**PLANNING COMMISSION
Meeting Agenda
Monday – February 8, 2010
7:00 PM - Regular Meeting
City Council Chambers – 155 NW 2nd Avenue**

STAFF REPORT

DR 09-02

300 Block of S. Walnut Street

SIGHT DISTANCE
Sight Lines at Access Driveways

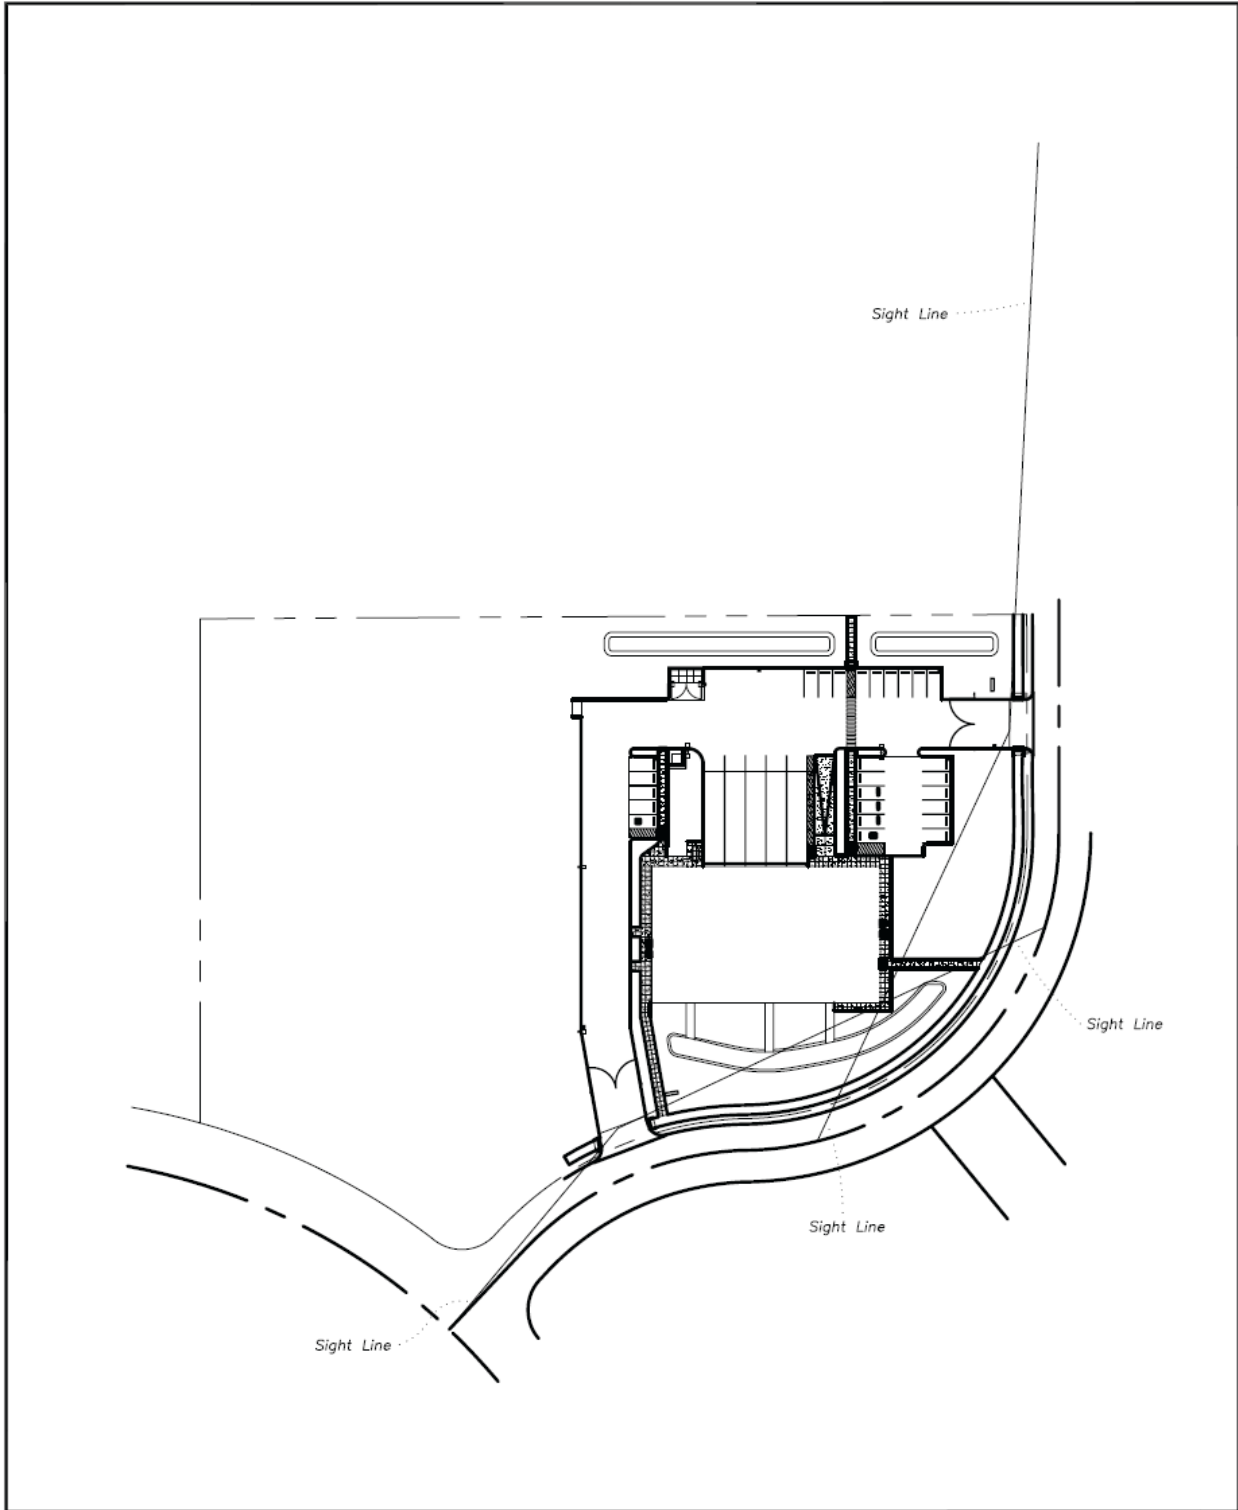
project (*see Exhibit H*), and the study concluded that the proposed development does not create any trip generation issues, that the driveway spacing along S. Walnut Street is adequate. Because of the curvature of S. Walnut Street in relation to the driveway placement, the Transportation Engineer did find that maintaining adequate site distance is a concern that should be addressed (*see Exhibit H – page 3 and Figure A-2*). The study found that the following recommendation will address the concern and maintain adequate site distance: “To ensure sight distance will continue to be met at the site access driveway, the sight line shown in Figure A-2, in the Technical Appendix, should be kept clear of any structures and growth which extend higher than 3.5 feet from the ground.” In review of the applicant’s proposed landscaping plan, it appears that the only plants the applicant plans to plant inside the sight distance lines that are taller than 42-inches are red alder trees (which mature to 50-90 feet tall), and that the most critical sight distance area appears to be where the sight distance lines converge adjacent the curve of the roadway. Therefore, it is recommended that approval of the development include a condition that the 3 red alder trees proposed inside the convergence of the sight distance lines be replaced by a plant material that will not grow higher than 42 inches.

At the east driveway, approximately 330 feet of sight distance is available to the south along S Walnut Street. Sight distance beyond 330 feet is restricted by the building. To ensure sight distance will continue to be met at the site access driveway, the sight line shown in Figure A-2, in the Technical Appendix, should be kept clear of any structures and growth which extend higher than 3.5 feet from the ground. To the north, the site plan extends only to the north property line. Using the site plan and also the plan set for S Walnut Street, it can be seen that S Walnut Street will not have any horizontal curvature that could restrict sight distance and as stated previously, no vertical curvature that could restrict sight distance. Therefore, sight distance will be in excess of 280 feet and thus satisfy the intersection sight distance requirement.

- At the time of building permit application, a revised landscaping plan shall be submitted to the City with the follow revision: the 3 red alder trees located inside the convergence of the sight distance lines near the curvature of the roadway, as illustrated in Figure A-2 of Exhibit H to the February 1, 2010 staff report, shall be removed and replaced by a plant material that will not grow higher than 42 inches. No plant materials or other features shall be allowed on the site within the area of sight line convergence that exceed 42 inches in height. (*condition # 14*)

14. At the time of building permit application, a revised landscaping plan shall be submitted to the City with the follow revision: the 3 red alder trees located inside the convergence of the sight distance lines near the curvature of the roadway, as illustrated in Figure A-2 of Exhibit H to the February 1, 2010 staff report, shall be removed and replaced by a plant material that will not grow higher than 42 inches. No plant materials or other features shall be allowed on the site within the area of sight line convergence that exceed 42 inches in height.
